**SAN LORENZO VALLEY WATER DISTRICT
CROSS COUNTRY PIPELINE CONSTRUCTABILITY
PEER REVIEW OF FREYER & LAURETA STUDY AND MEMO**

**Peer Review of March 2022 Study and
Draft Supplemental Evaluation Dated April 6, 2022**

24 NOVEMBER 2022
PROJECT NO. 12196

FIGURE 2: DEBRIS FLOW SOURCE AREAS

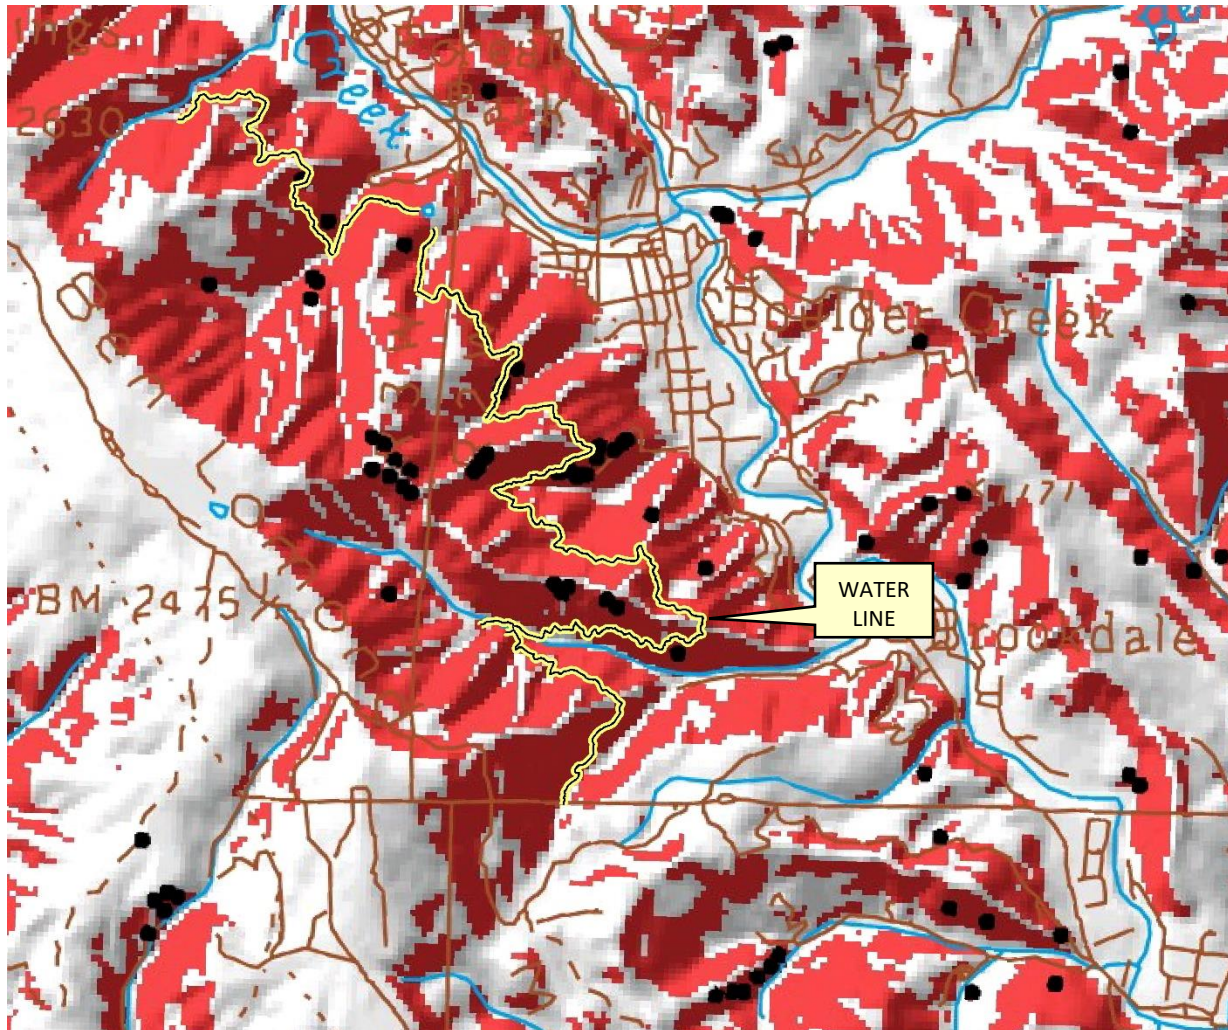
Our review finds that slopes in the project area greater than about 65% gradient can, in general, be classified as debris slide slopes having formed over time by repeated shallow debris slide type surficial landsliding, which is consistent with the findings of Ellen and Others (1997). These slopes, in general, are inherently prone to shallow debris slide/flow landsliding with the risk being greatest in colluvial slopes, headwall swales, steep streamside slopes, areas with perched ground water, surface runoff, low cohesion soils, etc.

Areas downslope of the pipeline alignment are subject to debris flow runout originating upslope landslides and multiple debris flow landslides occurred in the 1982 storms resulting in significant damage to homes and infrastructure, including in areas downslope of the waterline. Following the 2020 CZU fire, debris flow runout paths downslope of the waterline have been mapped by

FIGURE 3: DEBRIS FLOW INUNDATION AREAS
A Portion of Debris Flow Floodplain Workmap # 18 for the CZU Fire Zone
(from Atkins/Lavalin, September 2021)

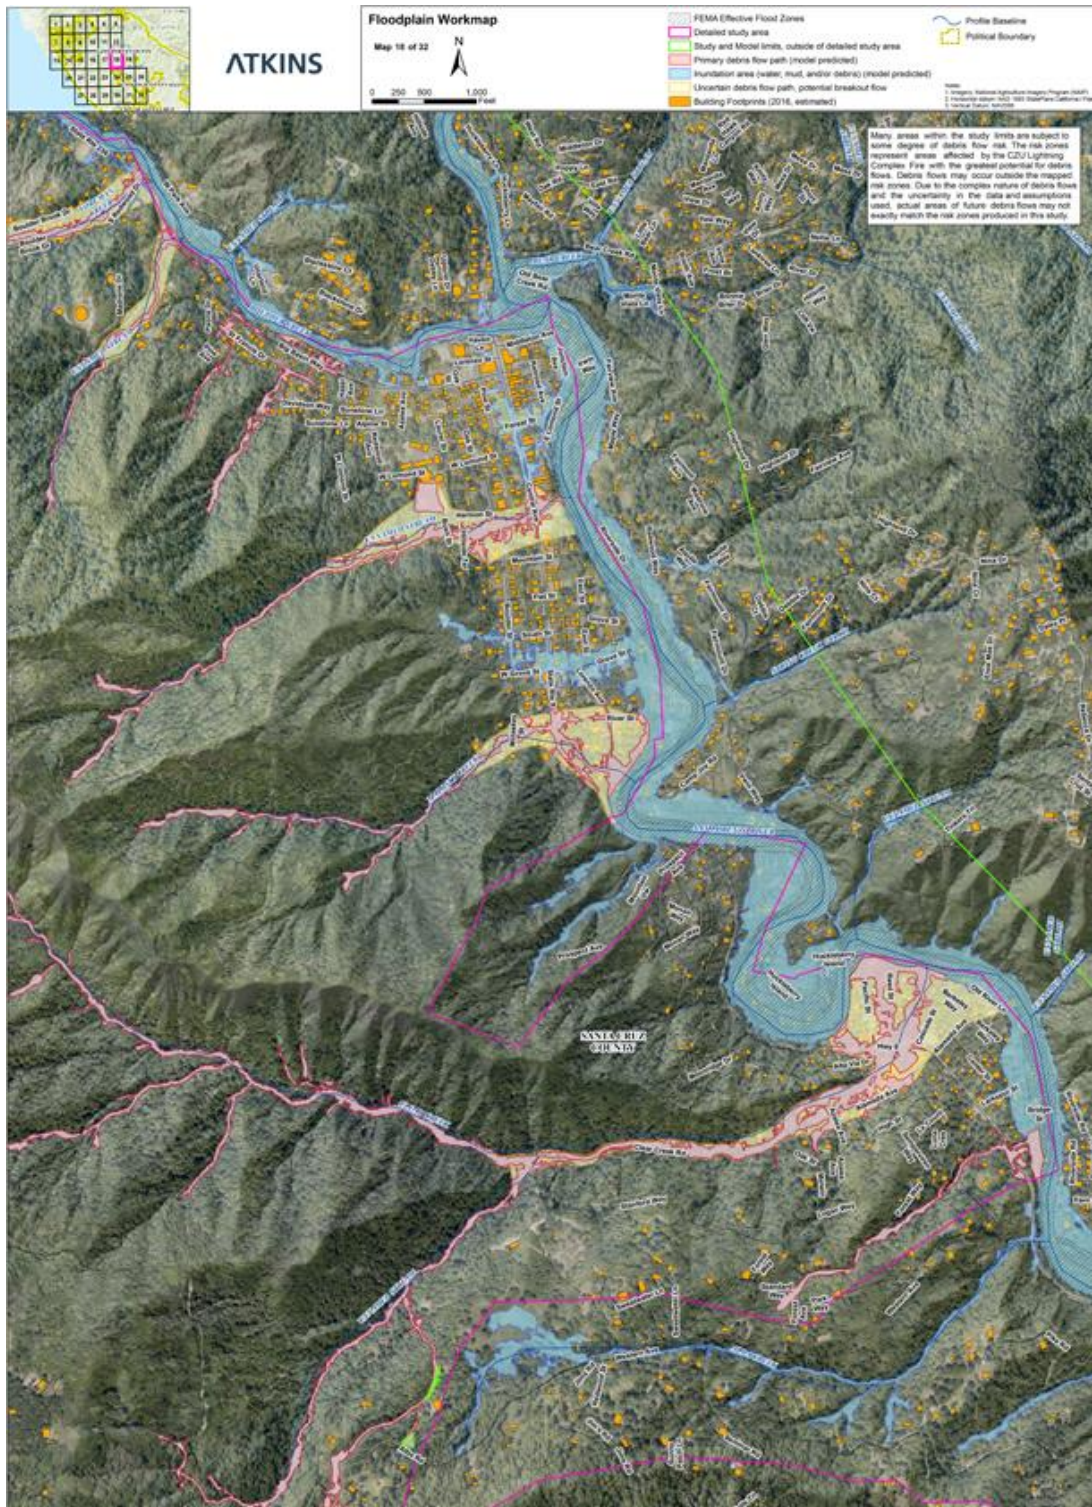
It must be understood that future landslides will occur along the steep slopes that the waterline crosses. The construction and expansion of the waterline bench can increase the risk of slope instability thru the placement of fill, undercutting of the hillside, and concentration of runoff. This risk increases with slope gradient and width of bench because of the larger associated cuts and fills. Mitigating this risk becomes more difficult, again with increased slope gradient and width of bench. In our opinion, it is very likely that permitting agencies will require a comprehensive geotechnical investigation and report to demonstrate at a minimum that the proposed improvement will not significantly increase the risk for instability. Mitigating the risk of natural landslides may not be feasible due to the size and depth of many of the slides.

Photograph 8: Example of Steep Failing Slopes along Existing Waterline Bench

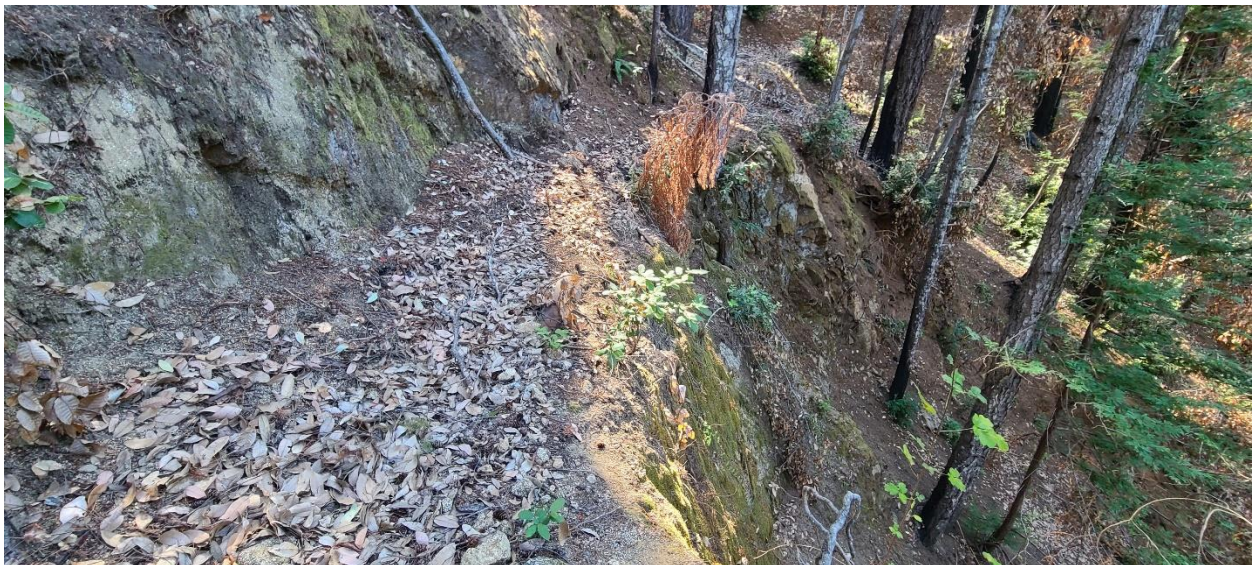
As discussed earlier, the steep slopes and existing slope failures that the waterline traverses present the most significant logistical and environmental constraint to the installation of a new waterline, and from our understanding this was one of the principal reasons the past waterline was originally installed by hand crews. Our preliminary GIS analysis of LiDAR derived topography finds over 4,600 feet of the alignment traverse slopes steeper than 100% gradient. The steepness of the slopes is extensive and inclusive in many areas, and it will be impossible to construct a stable access bench without

excavating large cut slopes into the underlying bedrock. Outboard fill wedges cannot be maintained on the side of these steep slopes. The access trail would have to be constructed entirely on cut with excavated spoils hauled away and/or the outer edge of the fill prism fully retained. The major effort required to build this section of the access trail and the erosion problems created by necessity, prohibit construction of the access trail along these portions of the pipeline route. Additional studies and discussions with a qualified contractor to determine equipment access will be required to further identify these choke points.
